FACILITY NAME: _____ Surry _____

REPORT NUMBER: _____ 2009-301 _____

POST EXAM COMMENTS

VIRGINIA ELECTRIC AND POWER COMPANY
SURRY POWER STATION UNITS 1 AND 2
WRITTEN LICENSE EXAMINATION COMMENTS

NUMBER	PROCEDURE TITLE	REVISION
1D-C6	PRZR PWR RELIEF VV LO AIR PRESS	9
		PAGE 2 of 6

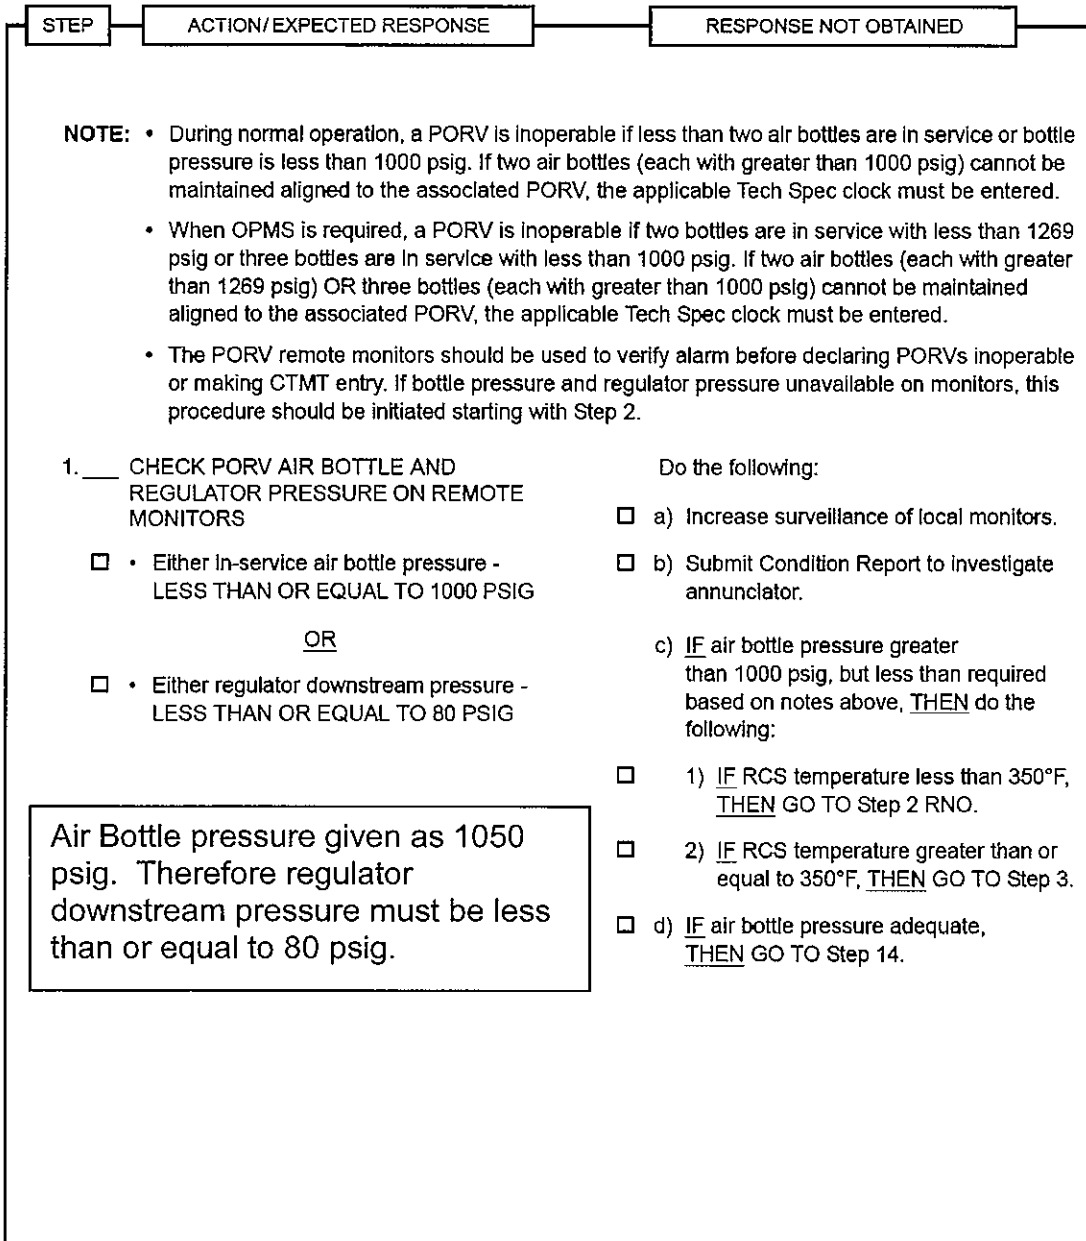
Given the Unit conditions presented in the stem of the question, Technical Specification 3.1.A.6 is NOT met.

The conditions given in the question state that annunciator 1D-C6 (PRZR PWR RELIEF VV LO AIR PRESS) has actuated and that Pressurizer PORV air bottles are pressurized to 1050 psig. Since annunciator 1D-C6 will only annunciate when Pressurizer PORV air bottle pressure is less than 1000 psig or when Pressurizer PORV Back-up Air System (i.e., air pressure downstream of the pressure regulator) is less than 80 psig, it can logically be concluded that the cause of the alarm was due to low air pressure downstream of the pressure regulator.

Since air pressure downstream of the pressure regulator is less than 80 psig, the PORVs must be declared inoperable in accordance with ARP 1D-C6 Step 4 and Technical Specification 3.1.A.6. This means that the LCO for 3.1.A.6 is NOT met and that the required operator actions are to restore the Pressurizer PORV backup air supply within 14 days OR be in HSD within the next 6 hours

Based on the above information the correct answer for this question should be (C), the ARP and plant conditions show the Technical Specification is NOT met.
